RE: PZ# 24-12000027 Vera Site Plan ([494212000070](#))

The above-referenced Site Plan application has been reviewed by the Development Review Committee and discussed at the April 16<sup>th</sup>, 2025 DRC Meeting. Comments are being addressed and resolved with each discipline reviewer, though one outstanding comment is related to a necessary zoning code modification/waiver that would otherwise result in a development conflict with the City's CPTED guidelines as well as adjacent property conditions. We would like to take the opportunity to justify the need for Director modification/waiver in accordance with code sections 155.5203.F.2.e [Perimeter Buffers; Applicability].

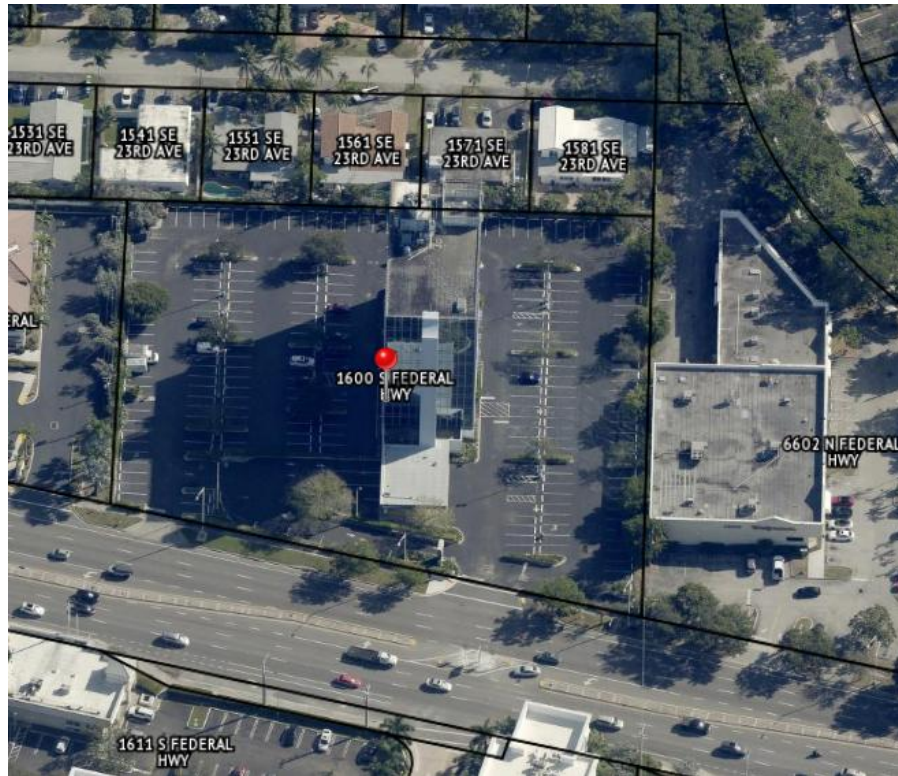
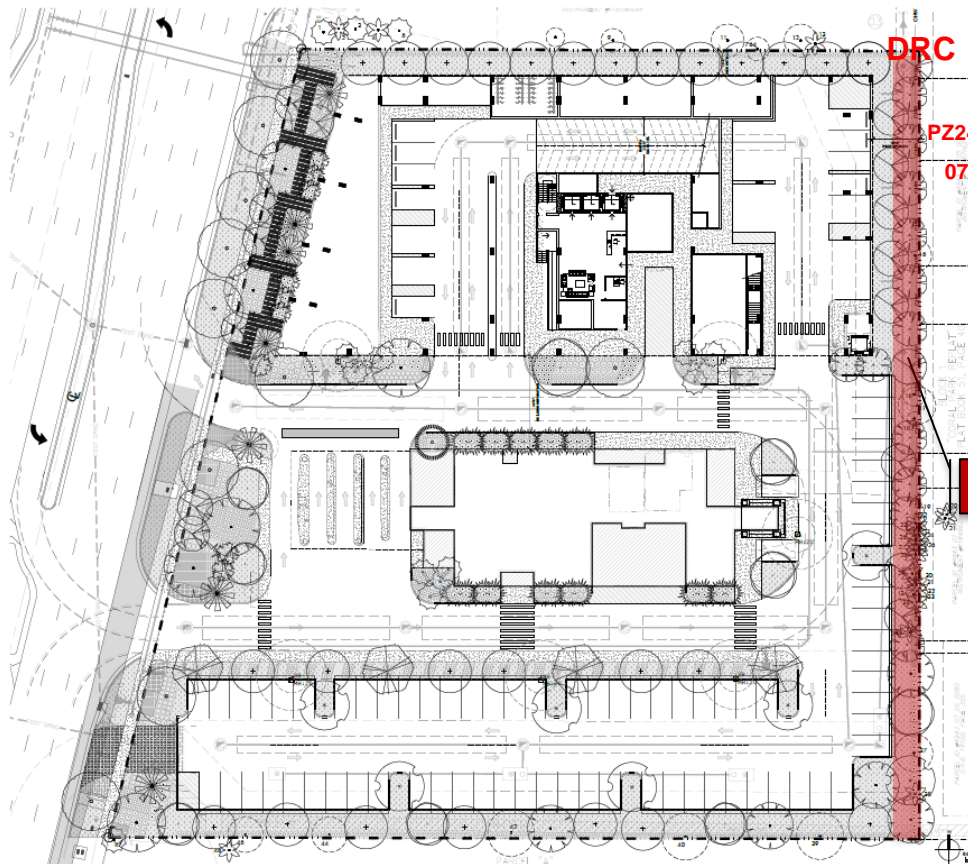
**URBAN FORESTRY comment 7** states, "Please be aware that the required Type B buffer fence location as proposed will require a CPTED waiver signed by the DSD."

As shown below, the property abuts multifamily residential zoning to the east where a Type B buffer is required per Table 155.5203.F.3. For the safety and privacy of the residential properties, we request all buffer landscaping to be installed inside of the wall, rather than placing the wall in the middle of the 10 foot-buffer. If a wall is placed in the middle of the buffer, maintenance of the landscaping and wall will be necessary, thereby possibly facilitating a maintenance worker to trespass onto residential private property. If the residential properties include a fence or wall on their private property, an additional wall will create an "alley" of unmaintained area that invites trespassing and possibly illegal activities. Providing the fence in the middle of the east buffer would put a maintenance worker near the railroad tracks which creates an unsafe condition for the maintenance worker.

As mentioned, requiring the buffer barriers in the middle of the 10-foot buffer not only violate the city's CPTED guidelines for Natural Surveillance but poses a safety risk for maintenance due to adjacent property conditions. Below is a summary of the buffer modifications/waivers we are requesting, with a diagram for these:

Buffer	Barrier Material	Barrier Location
East Type B	Solid fence, no waiver requested	Exterior boundary of buffer, rather than middle
